## MINISTRY ASSESSMENT

File: PE-11678

<b>Application:</b> major amendment		<b>Pre-Application Date:</b> April 3, 2007
<b>SIC:</b> 0612	<b>Production Capacity:</b> 22,000 tpd	<b>Application Date:</b> August 21, 2009
<b>Applicant:</b> Mount Polley Mining Corporation		
<b>Location of Facility:</b> Likely, BC

The applicant has requested to include an additional point of release for mine effluent, to Hazeltine Creek with a maximum flow rate of 18,150 m<sup>3</sup>/day.

Below is a figure from the assessment report which shows the mine orientation in Relation to Bootjack Lake, Polley Lake, Hazeltine Creek and Quesnel Lake.

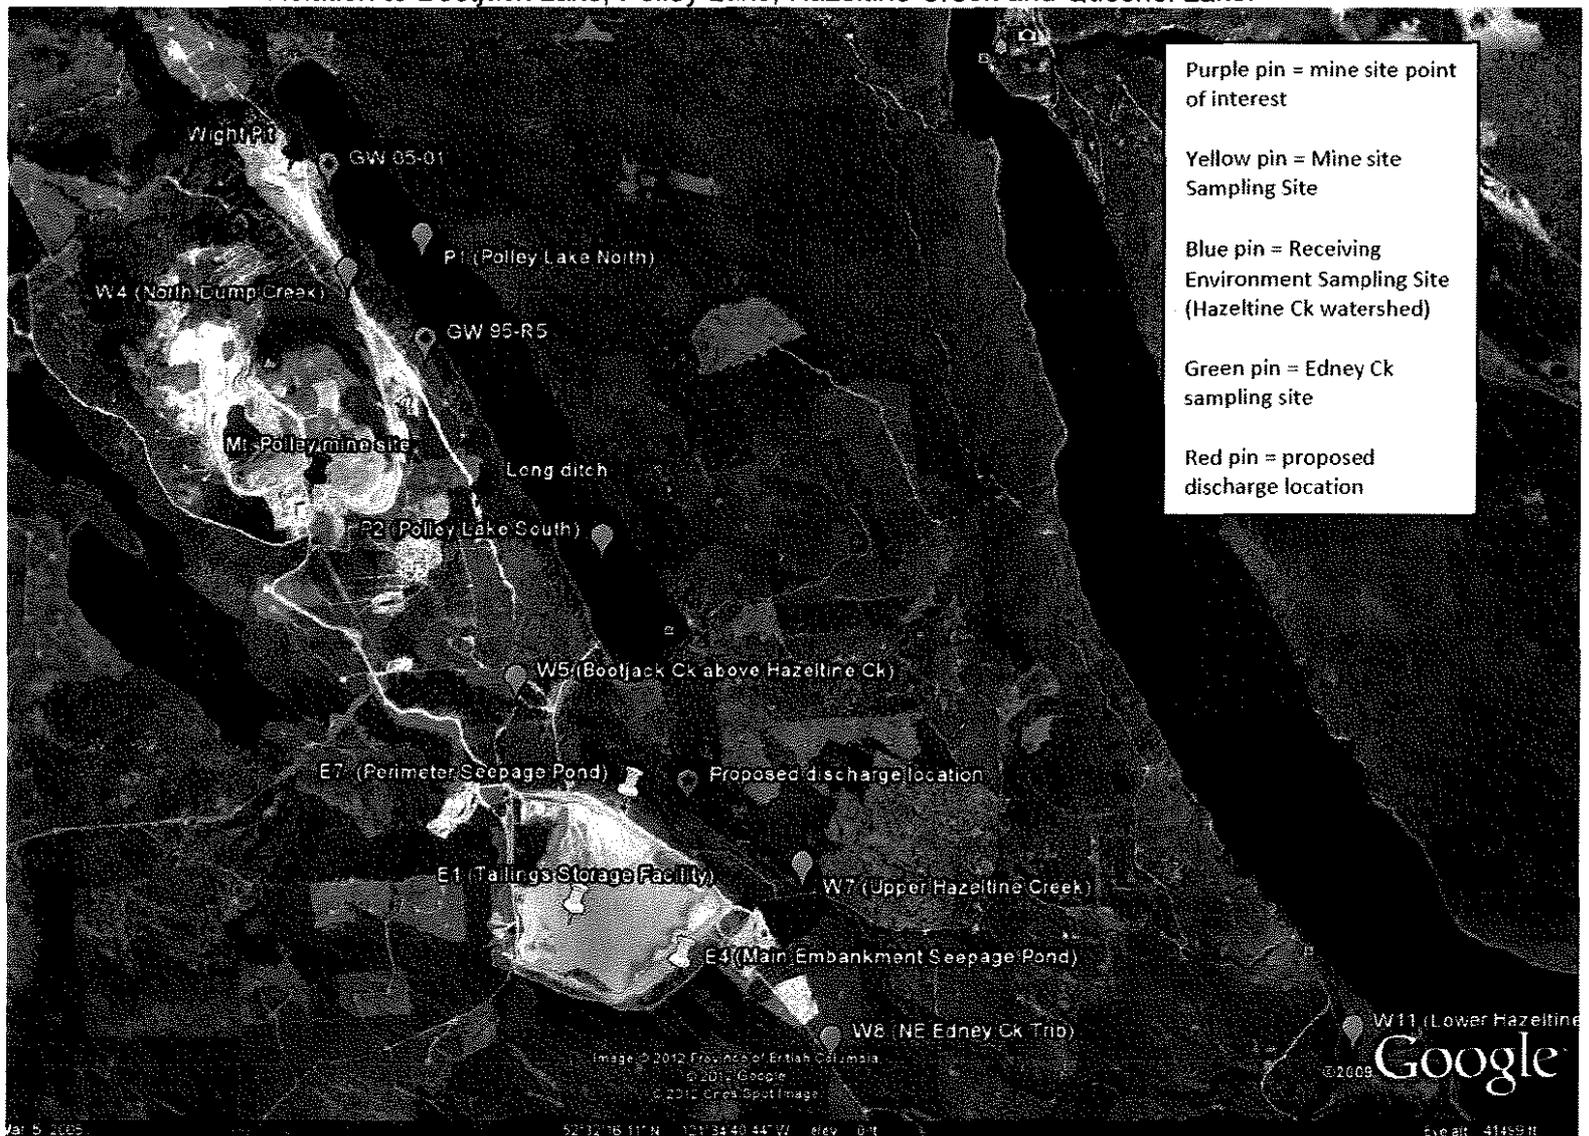
CS has recommended that the location of the discharge site should avoid the gravel bar/braided area in the creek to ensure adequate mixing in the creek at low flows. Linda Sheffield, Lands Officer has forwarded the Lands Act application (5407625) and the Water Act Approval (A5-4397) and Forest Act approval for the discharge pipeline to EPD which confirm that the proposed discharge location would be upstream of the gravel bar/braided area.
